DESCRIPTION AND SAFETY ANALYSIS OF  
PROPOSED CHANGES TO  
APPENDIX A TECHNICAL SPECIFICATIONS OF  
FACILITY OPERATING LICENSES  
NPF-37, NPF-66, NPF-72, AND NPF-77

### BYRON UNITS 1 & 2

### BRAIDWOOD UNITS 1 & 2

### **EVALUATION OF SIGNIFICANT HAZARDS CONSIDERATIONS FOR PROPOSED CHANGES TO APPENDIX A TECHNICAL SPECIFICATIONS OF FACILITY OPERATING LICENSES NPF-37, NPF-66, NPF-72, and NPF-77**

FIGURE 3.1-0

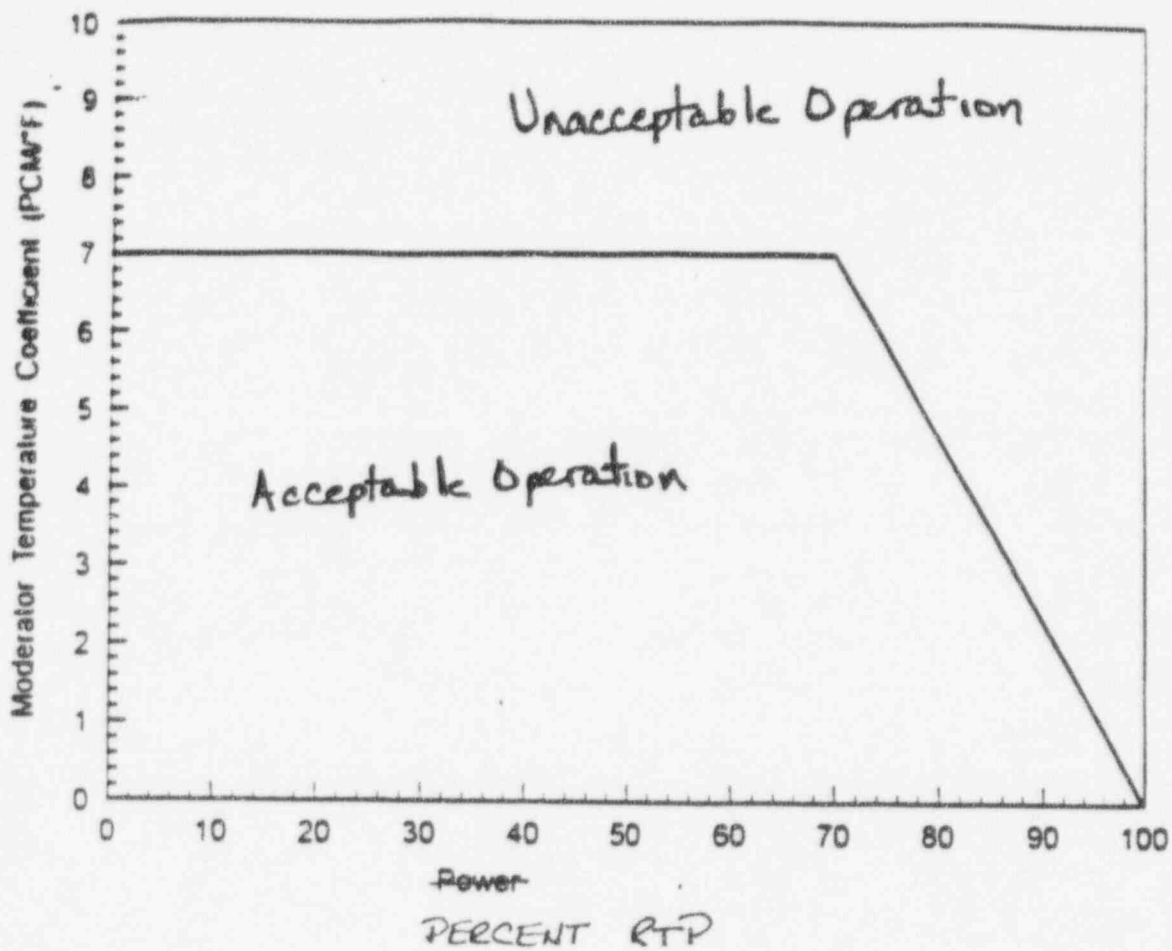
- 3.1.1.3 The moderator temperature coefficient (MTC) shall be within the limits specified in the Operating Limits Report (OLR). The maximum upper limit shall be less than or equal to that shown in Figure 3.1-0.

FIGURE 3.1-0

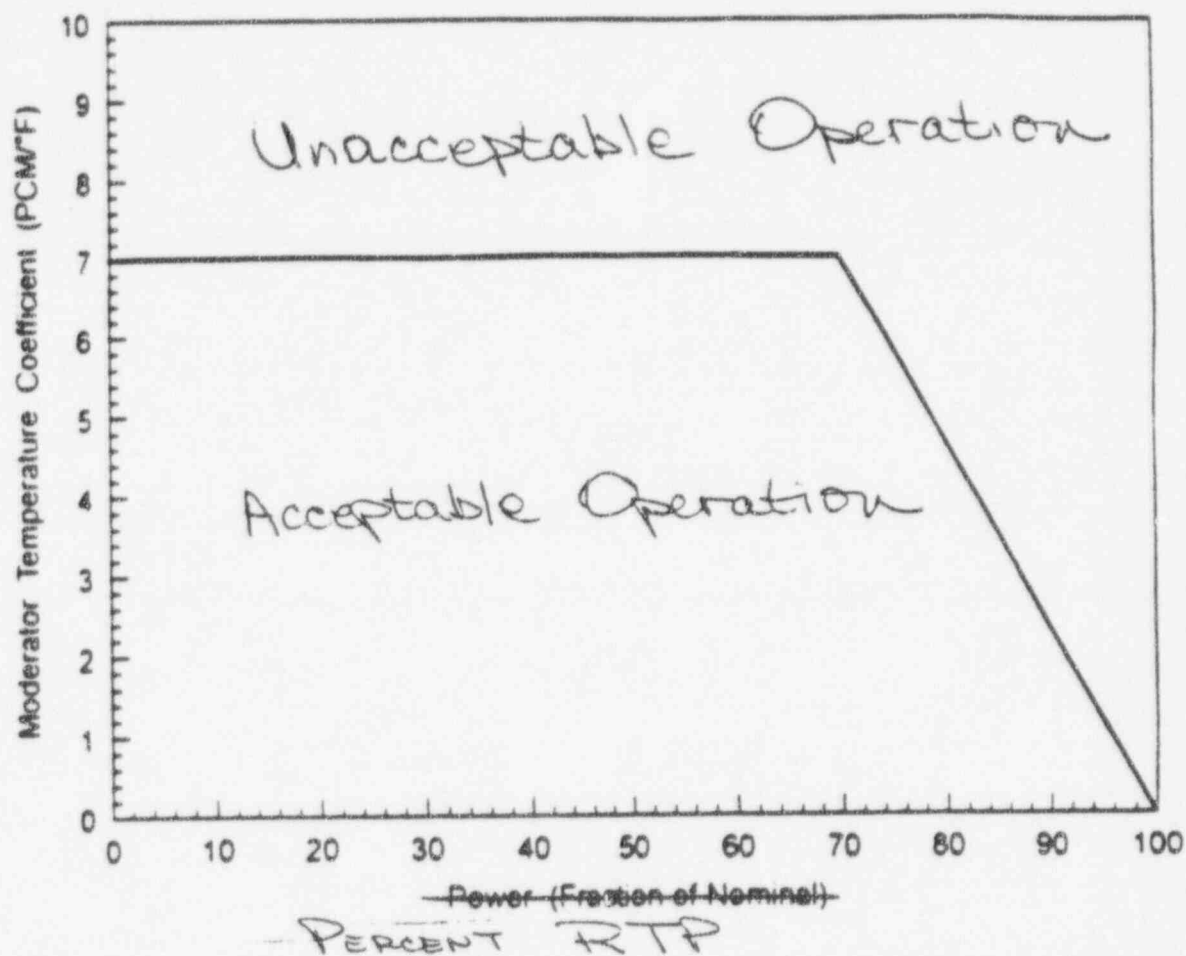
- 3.1.1.3 The moderator temperature coefficient (MTC) shall be within the limits specified in the Operating Limits Report (OLR). The maximum upper limit shall be less than or equal to that shown in Figure 3.1-0.
